HIGHWAY WORK PROPOSAL

<u>COUNTY</u>	<u>STATE PROJECT</u>	<u>FEDERAL</u>	<u>PROJECT DESCRIPTION</u>	<u>HIGHWAY</u>
Rock	3653-00-70	N/A	Cth S - Cth O; Turtle Creek Bridge, B-53-0386	CTH J

Addendum No. 01
ID 3653-00-70
Revised Sheet 42
July 27, 2021

Addendum No. 01
ID 3653-00-70
Revised Sheet 50
July 27, 2021

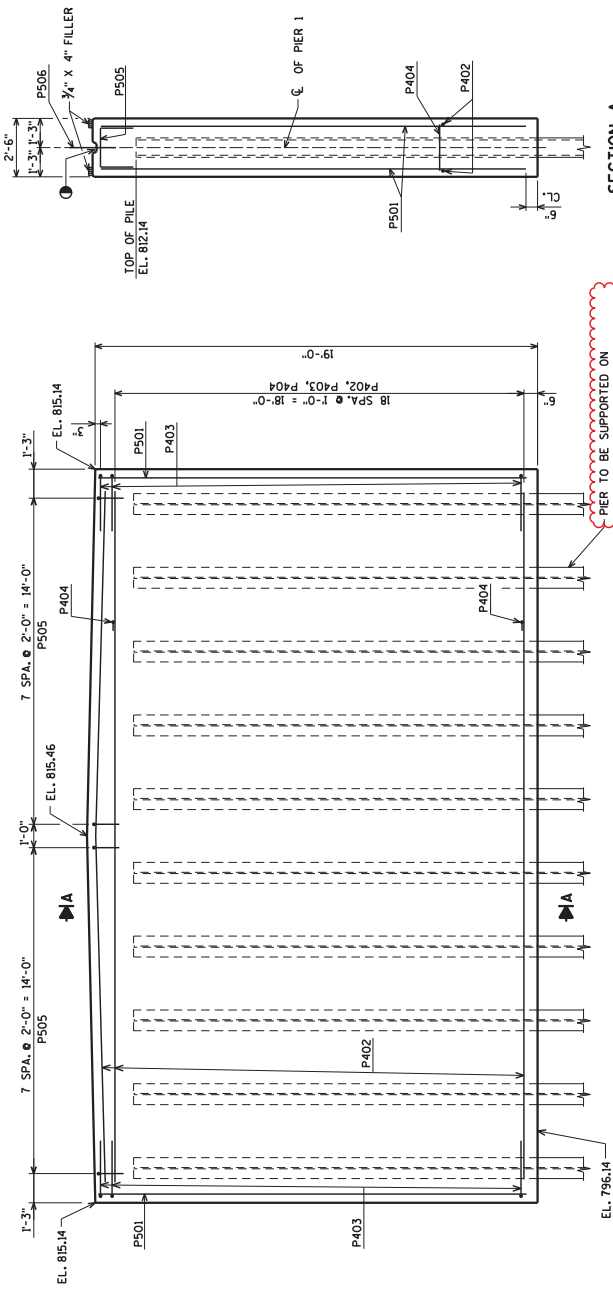
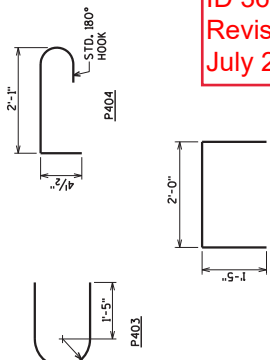
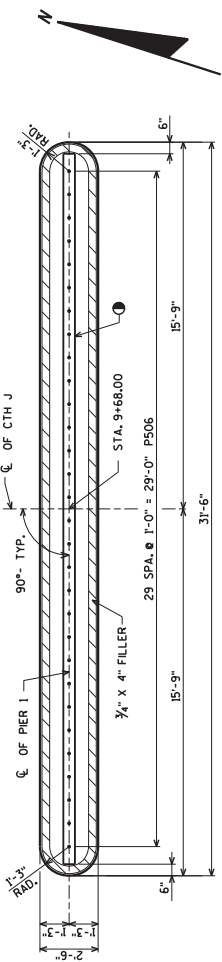
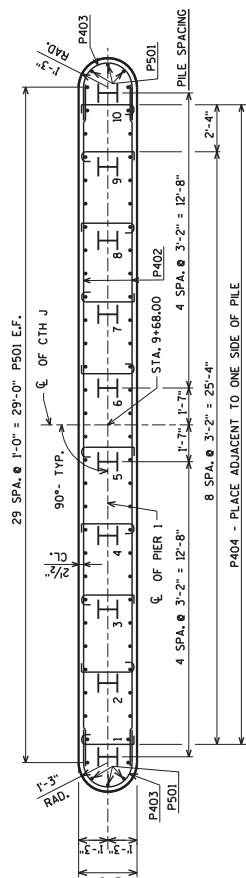
Revised Plan Sheets	
Plan Sheet	Plan Sheet Title (brief description of changes to sheet)
41	General Plan (Pile points removed and clarified that driving not required for pre-bored piles at piers)
42	Quantities and Notes (Revised pile point quantity)
43	Subsurface Exploration (Removed pile points at piers)
50	Pier 1 (Pile points removed and clarified that driving not required for pre-bored piles)
51	Pier 2 (Pile points removed and clarified that driving not required for pre-bored piles)

PIER TO BE SUPPORTED ON
HP 10 x 42 STEEL PILING WITH PILE
POINTS DRIVEN TO A RECORDING
RESISTANCE OF 180 TONS PER PILE.
ESTIMATED LENGTH 26'-0".
PRE-BORE PILING 10'-0".
